# SCHWEIZER SERVICE BULLETIN

C1B-028  
24 Oct 2008

**SUBJECT:** MODIFICATION OF CABIN DOOR HINGES

**MODELS AFFECTED:** • 269C-1 Model Helicopters Serial No. 0001 through 347

Figure C1B-028-1. Door Hinge Plate

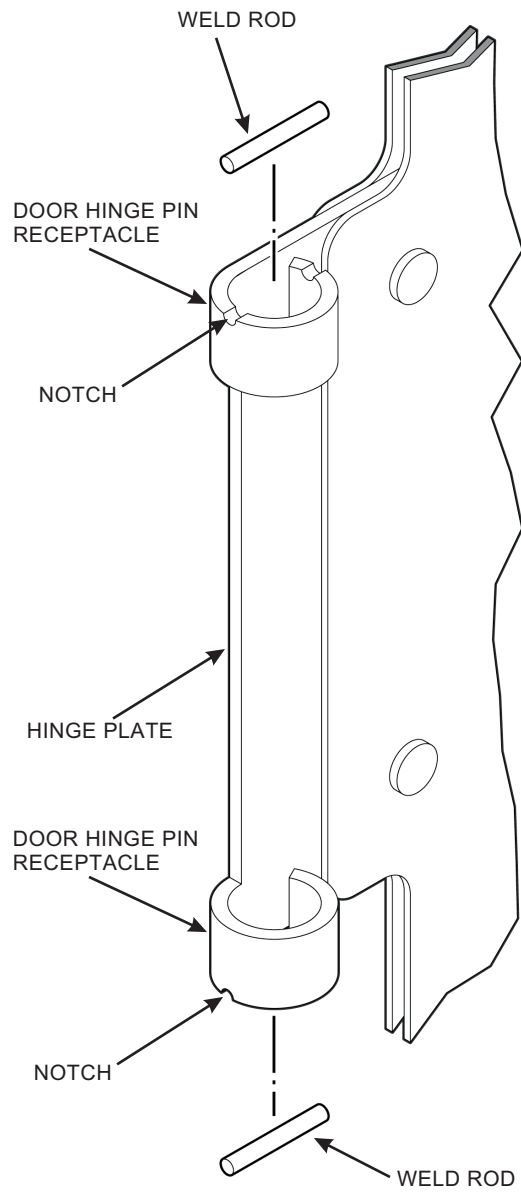
**PREFACE:** • A report has been received that a cabin door separated from a helicopter in flight as a result of the door hinge pins disengaging from the hinge assembly. The hinge pins became free when a serrated release pin came out of the hinge pin. A modification of the door hinge plate has been developed that will prevent the hinge pins from disengaging if the release pins are lost.

- c. Remove paint from two pin receptacles of both door hinges. File small notches in outside edges of pin receptacle 180° apart and centered on holes as shown in Figure C1B-028-1. Do not exceed one half diameter of weld rod.
- d. Place weld rod in notches with 0.0625 inch overhang on each side. Using overhang as filter, TIG weld rod to edge of hinge receptacle in accordance with Advisory Circular AC 43.13-1B, Chapter 4, Section 5. File excess material flush with outside diameter of receptacle.
- e. Restore paint finish in accordance with HMI Appendix D.
- f. As required, install doors on helicopter.

Instead of modifying the door hinge plates as directed below, the hinge plates may be replaced with a 269A4755-13 hinge half that has been reconfigured with a cap welded to the outside end of the door hinge pin receptacle.
